AN EXCHANGE OF TECHNICAL INFORMATION  
**VOLUME 19 NUMBER 1** ABOUT CARRIER TRANSCOLD CONTAINER PRODUCTS

**June 2013**

**TechFact** – NEW Look to the ThinLINE® and PrimeLINE® units.

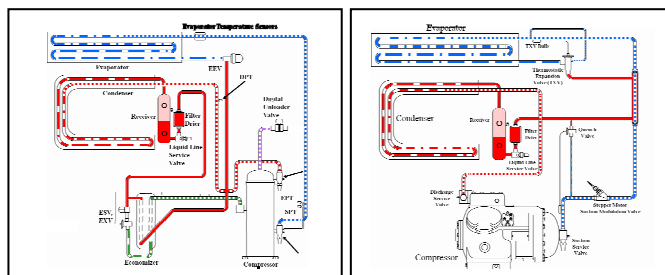
PrimeLINE models 561-2xx and greater along with ThinLINE models 541-5xx and greater have a new look (shown below), which is the result of our continuous drive to improve efficiency while also reducing overall weight and improving serviceability.

Following is a listing of the key changes:

**Condenser Coil** – Changed from a flat, 7 mm coil to a C shaped 7mm 2 row coil (coil p/n 81-04203-20).

**Condenser Motor** – Changed from single to three phase (p/n 54-00655-20, fan blade p/n 38-00620-01).

**Receiver Tank and Filter Drier** – Moved from under the condenser coil to next to the condenser coil (PL p/n 79-04049-00, TL p/n - 01).

**Control Box Door** – The unit display and the keypad are installed on the door. Door now opens outward from the unit. Door, less keypad and display, is part number 79-04018-00 w/Philips screws, -01 w/ Latches).

**Evaporator Coil** – Changed from inward sloped to an outward sloped coil. (p/n 81-04186-20).
